Access Compliance Report

Public Rights-of-Way

(Curb Ramps)

Intersection ID: 2606	Main Street: CROWNVISTA_DR	Cross Street: FAIRVISTA_DR	Location: W
ADA ID: F1C844B1016B	Ramp Type: PerpDiag	Initial Pass/Fail: Fail	Overall Compliance: No
Severity Score: 10			
Codes/Mitigation Info/Possible Solution		Field Measurements/Component Compliance

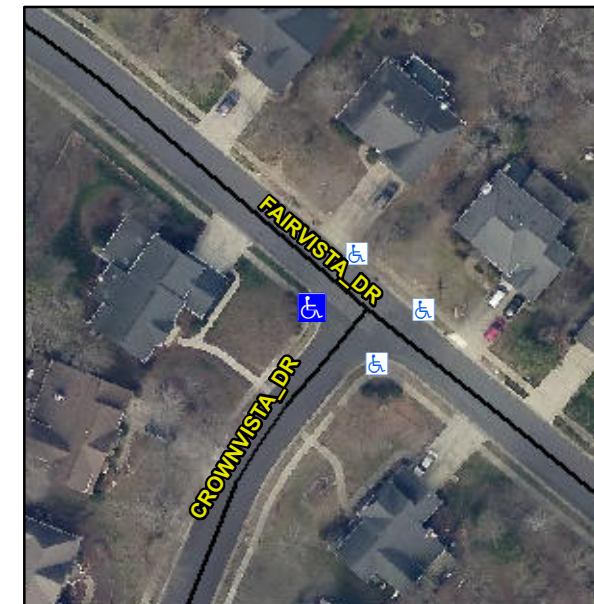
R304.5.1, R304.5.3

Compliance	Description	Data	Compliance	Description	Data
N/A	Ramp Length (in)	48.0	Yes	Ramp Slope (%)	6.8
No	Ramp Width (in)	47.0	No	Ramp XSlope (%)	3.6
N/A	Flare Type LT	N/A	N/A	Flare Type RT	N/A
N/A	Flare Slope LT (%)	N/A	N/A	Flare Slope RT (%)	N/A
N/A	Flare Traversable LT?	N/A	N/A	Flare Traversable RT?	N/A
N/A	Landing Length (in)	N/A	N/A	DWS Provided?	N/A
N/A	Landing Width (in)	N/A	N/A	DWS Contrast?	N/A
N/A	Landing Slope (%)	N/A	N/A	DWS Length (in)	N/A
N/A	Landing X Slope (%)	N/A	N/A	DWS Full Width?	N/A
N/A	Landing Curb? (Y/N)	N/A	N/A	DWS Offset (in)	N/A
N/A	Shared Landing?	N/A			
N/A	Gutter Ponding?	N/A	N/A	Gutter Slope (%)	N/A
N/A	Gutter Lip Ht (in)	N/A	N/A	Gutter X Slope (%)	N/A
N/A	Painted X Walk1?	No	N/A	Painted X Walk2?	No
	X Walk 1 Direction	To SE		X Walk 2 Direction	To NE
N/A	X Walk 1 Width (in)	N/A	N/A	X Walk 2 Width (in)	N/A
	X Walk 1 Slope (%)	4.8		X Walk 2 Slope (%)	2.0
	X Walk 1 X Slope (%)	1.7		X Walk 2 X Slope (%)	4.3

Remove & Replace Curb Ramp With Two New Directional Ramps or Equivalent.
